SUBJECT: Scenic Subdivision, Staff response to Addendum 1

Scenic Apartments City Council Appeal

TO: Mayor Rick Kaysen and Cheyenne City Council
FROM: Tom Mason, MPO Director
SUBJECT: Scenic and Bluffs 9th and Transportation History
DATE: February 1, 2013

Figure 1

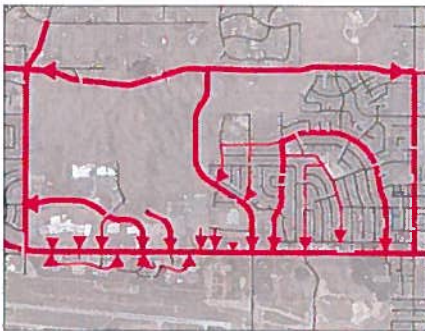
Buffalo Ridge was developed in the 1950's and at that time the land use, transportation network, and block pattern for the neighborhood were established. This pattern displayed in Figure 1, shows that the street system collected all traffic and turned it southward towards Dell Range which, at the time, was a small two-lane road and traffic volumes were very light. Mid-twentieth century Cheyenne was too early for the recognition of the importance of regional transportation planning, as this later adopted practice, helped guide subdivision's roadway networks to take into account the hierarchy and functions of mobility and access such as connections to future growth beyond their own boundaries.
